# Access Compliance Report

## Public Rights-of-Way

### (Pedestrian Signals)

| ADA ID: F92DF9315BBC                    | Signal Type: Two Push Buttons-Non APS | Overall Compliance: No                  | Severity Score: BTN 1:N/A BTN 2: N/A No BTN: N/A |

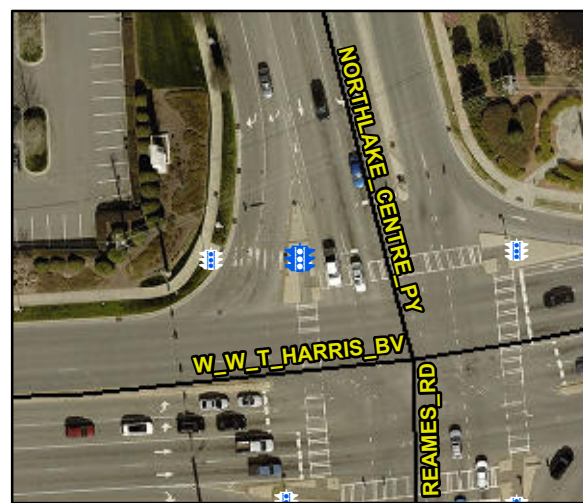
| Compliance | Description                             | Data    | Compliance | Description                            | Data |
|------------|-----------------------------------------|---------|------------|----------------------------------------|------|
| No         | B 1 FWD Approach?                       | No      | No         | B 2 FWD Approach?                      | No   |
| No         | B 1 PARA Approach?                      | No      | No         | B 2 PARA Approach?                     | No   |
| No         | B 1 Clear Floor Space Slope (%)         | 4.7     | Yes        | B 2 Clear Floor Space Slope (%)        | 1.6  |

| No  | B 1 DistanceTo Curb (in)  | 15.0          | No  | B 2 DistanceTo Curb (in)  | 16.0          |

Possible Solutions: Replace Signal Push Button With APS Button on New Post.  
Remove & Replace Sign. Remove & Relocate Sign.

PROW/ADA: R209.1, TMUTCD 4e.08, R404.2, R404.3, R404.7.1, R404.7.2
